Rezoning Transportation Analysis

Petition Number: 2026-021

General Location Identifier: 20511283

1. ~~Comprehensive Transportation Review (CTR):~~

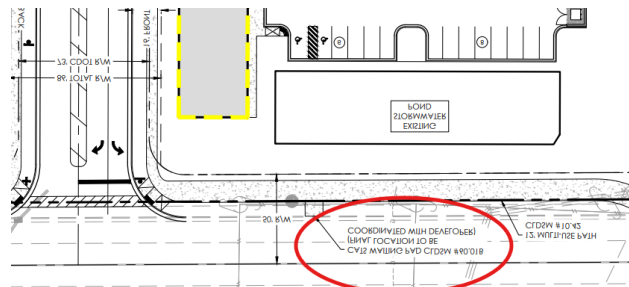
~~A Traffic Impact Study (TIS) is not required for the complete review of this petition due to the site generating site trips under ordinance thresholds found in the Charlotte Streets manual Table 3.1 and/or not triggering any other City TIS requirements.~~
